STATE OF WASHINGTON
DEPARTMENT OF ECOLOGY

Re: Dangerous Waste Compliance Inspection on March 12, 2015 at the Hanford Site PUREX Plant and Storage Tunnels, Resource Conservation and Recovery Act (RCRA) Site ID: WA7890008967, Nuclear Waste Program (NWP) Compliance Index No. 15.517

**Washington Department of Ecology
Nuclear Waste Program
Compliance Report**

Site: Plutonium-Uranium Extraction (PUREX) Plant & Storage Tunnels
RCRA Site ID: WA7890008967
Inspection Date: March 12, 2015
Site Contacts: Joel Williams Jr., CH2M Hill Plateau Remediation Company (CHPRC)
Tony McKarns, United States Department of Energy (USDOE)
Phone: (509) 376-4782, Joel Williams Jr.
FAX: (509) 372-2828, Joel Williams Jr.
Site Location: Hanford Site
At This Site Since: 1956 **NAICS#:** 56221, 924110, 54171
Current Site Status: Treatment, Storage, and Disposal (TSD) Facility
Operating Unit Group No. 2 and Closure Unit Group No. 25
Compliance Index #: 15.517

Photo 1: 211-A Bulk Cold Chemical Tank Farm (North of 202-A)

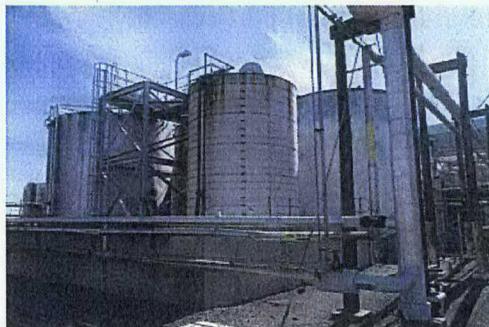
I didn't observe a current DW or MW inventory for individual tank or vessel systems in the PUREX Preclosure Work Plan, PUREX S&M Plan, or the PUREX Plant Part A. The statement above from the PUREX Preclosure Work Plan appears to address all tank and vessel systems in the PUREX Plant.
